SUBMISSION BY NORTH WEST SHELF GAS PTY LTD TO THE WA INDEPENDENT GAS PIPELINES ACCESS REGULATOR REGARDING THE PROPOSED ACCESS ARRANGEMENT FOR THE DAMPIER TO BUNBURY NATURAL GAS PIPELINE.

Figure 1. Proposed Zone 1 Delivery Sub Zones

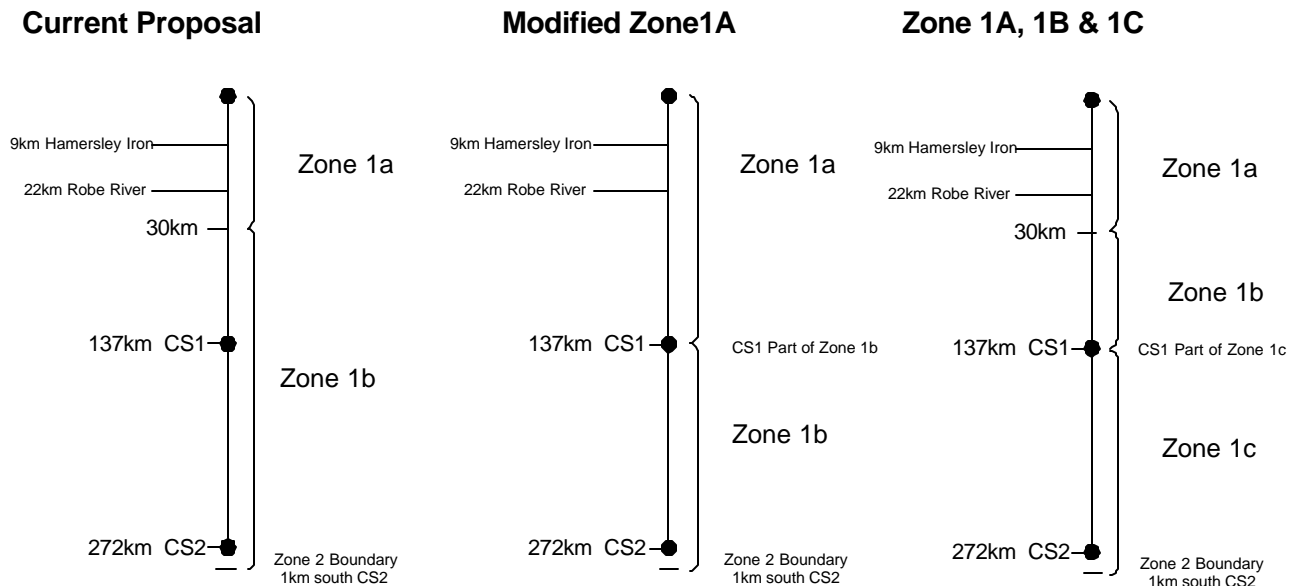
The length of Zone 1A is proposed to be 30 km. Given that the Delivery Points to Robe and Port Hedland are at about the 22 km mark, we cannot understand the rationale for the proposed boundary between Zone 1A and Zone 1B being at the 30 km mark other than it is stated in the AA documents that this is due to existing contractual arrangements. The tariff levels for a Delivery Point in Zone 1B are considerably higher than in Zone 1A and we would request that the Regulator determine the driver for the location of this boundary.

Indeed one could make a case that Zone 1A should extend to the suction of CS#1 so that all potential future loads such as those at Austeel's proposed iron to steel project near Cape Preston (at about the 70km mark) and a future connection from the DBNGP to the GGTP would be covered by Zone 1A. Alternatively, a third sub zone could be created such that Zone 1A covered up to the proposed 30km mark, Zone 1B covered the DBNGP from the 30 km mark to the suction of CS#1 and Zone 1C covered the remainder of Zone 1. These alternative arrangements proposed are shown in Figure 1 below.

In this way the benefit and value of the compression and delivery pressure of the gas delivered by the NWSJV at the start of Zone 1A could be made available to future users and only those seeking a Delivery Point in Zone 1 south of CS#1 would pay for CS#1 and the pipe downstream of CS#1. Such a structure would also ensure lower priced access to the GGTP for the other four north west producers (including the NWSJVs) who unlike the Apache Energy operated East Spar JVs and Harriet JVs are not directly connected to the GGTP.

The most competitive outcome that will be of benefit to GGTP customers and Western Australia's economy is likely to be one where the Regulator ensures that the DBNGP tariff to CS#1 is kept as low as practicable in order to facilitate equitable access by all north west producers to the GGTP. To this end, we would repeat our suggestion that the Regulator require that Zone 1 to be divided into three delivery sub zones with the middle sub zone extending to the suction of CS#1.
